## SUNDRY NOTICES AND REPORTS ON WELLS

8. Well Name and No.  
PIPELINE DEEP UNIT FEDERAL 0019. API Well No.  
30-025-2447010. Field and Pool, or Exploratory  
SWD DELAWARE11. County or Parish, and State  
LEA COUNTY, NM

Per NMOCD Order SWD-1255, Cimarex proposes to convert the Pipeline Deep Unit Federal No. 1 to SWD by performing the following operations:

RE: Convert well to SWD per NMOCD SWD-1255

## CURRENT WELLBORE

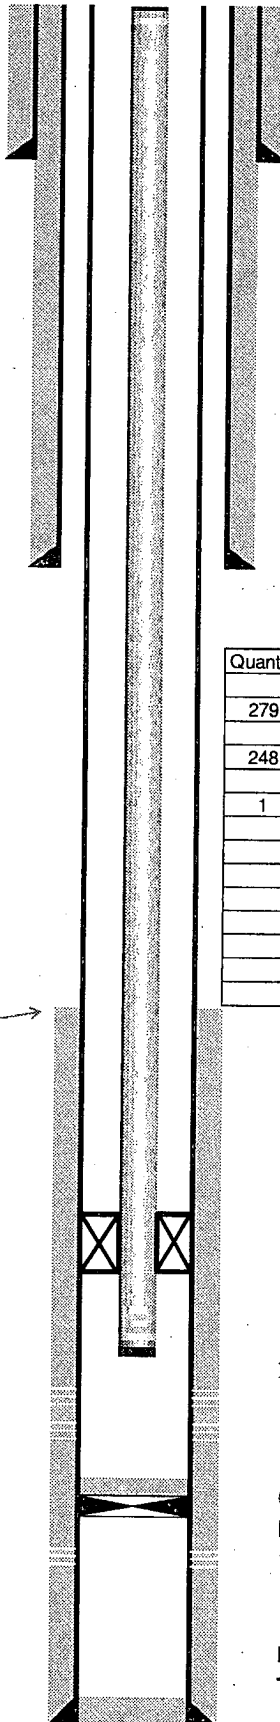
1. The 11-3/4 inch surface casing is set at 447 feet with cement circulated to surface.
2. The 8-5/8 inch intermediate casing is set at 5350 feet with cement circulated 0 sacks to surface. Our records indicated insufficient cement and top of cement is unknown.
3. **Run CBL to determine top of cement, and submit a copy to the BLM. If TOC is not to surface, remedial cement work will be required. Submit a Sundry for approval of remedial cement work.**

**A CIT is to be performed on 8-5/8 inch intermediate casing per Onshore Oil and Gas Order 2.III.B.1.h. Test pressure to be 1500 psi. \*If remedial cement work is done on 8-5/8 inch casing contact BLM to determine and get approval on adequate test pressure.**
